Macoupin Energy, LLC Shay No. 1 Mine

National Pollutant Discharge Elimination System (NPDES) Permit Responsiveness Summary

Illinois Environmental Protection Agency
Office of Community Relations
August 18, 2015

Macoupin Energy, LLC.
Shay No. 1 Mine
Renewal of Permit
Permit Number IL0056022

figure 1.3
WATER FLOW BALANCE DIAGRAM
EXISTING & PROPOSED
MACOUPIN ENERGY, LLC - SHAY NO. 1 MINE
CARLINVILLE, ILLINOIS

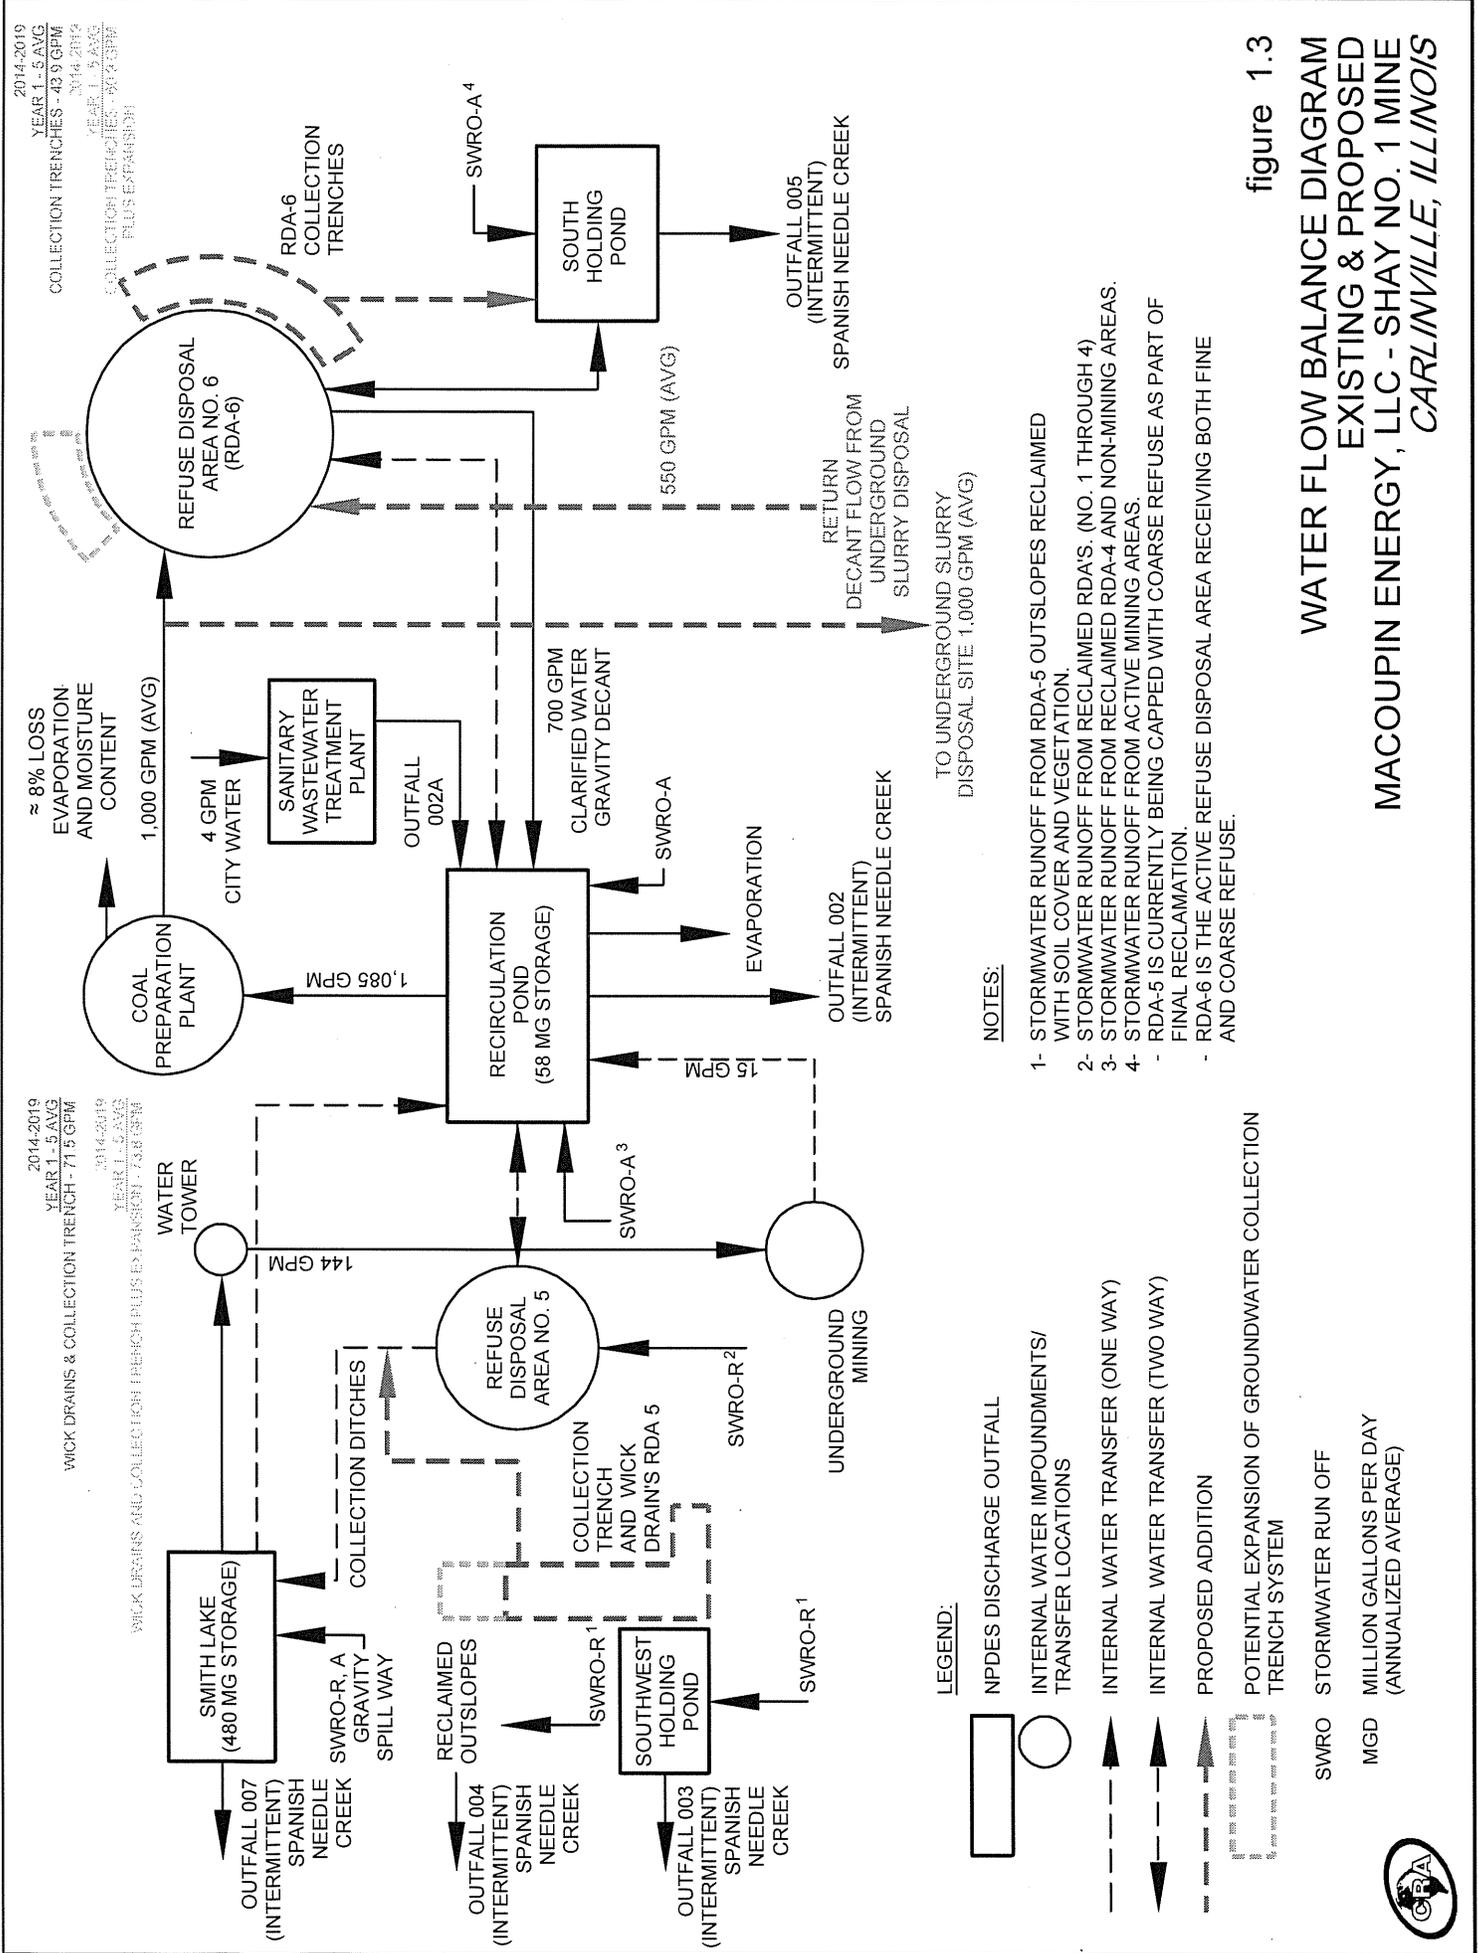
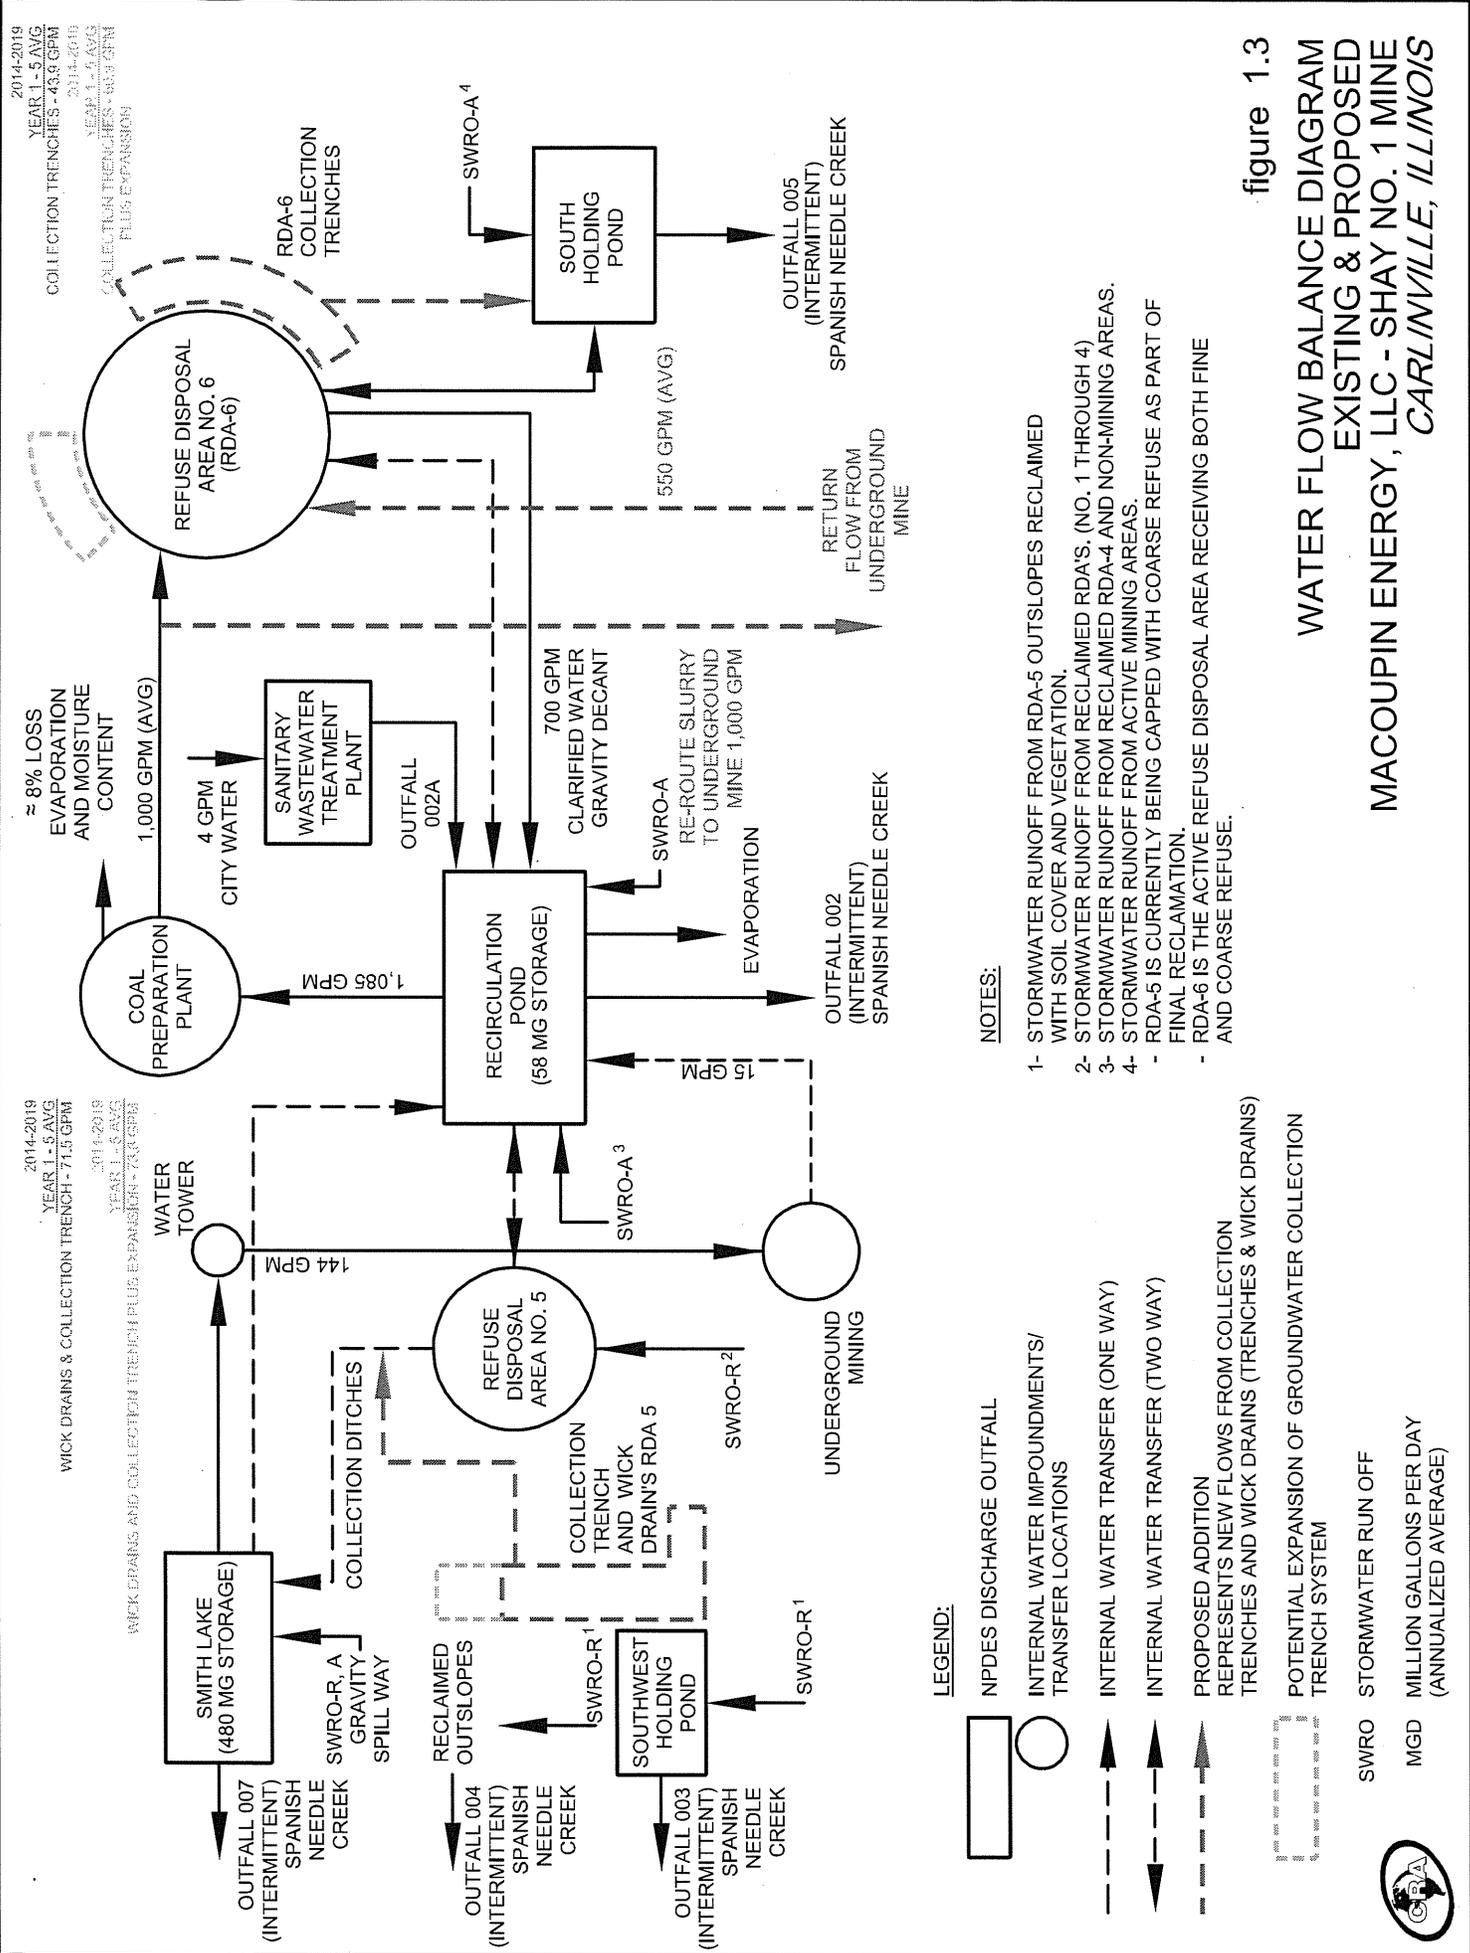
3. What waste streams are allowed to empty into Smith Reservoir?

4. Are there withdrawals from the Smith Reservoir being permitted?

There is an emergency overflow from RDA Number 5 that empties into Smith Reservoir (Lake). Refer to the attached Water Flow Balance Diagrams contained in Log No. 3177-15 in the Illinois EPA files and are available for review under the Freedom of Information Act.

There is a return pump for makeup water from Smith Reservoir (Lake) that is approved. Refer to the attached Water Flow Balance Diagram. Smith Reservoir (Lake) is on the mine property, and a treatment works for the mine. Since the treatment works is not a water of the State, no permit is necessary to withdraw water from the reservoir.
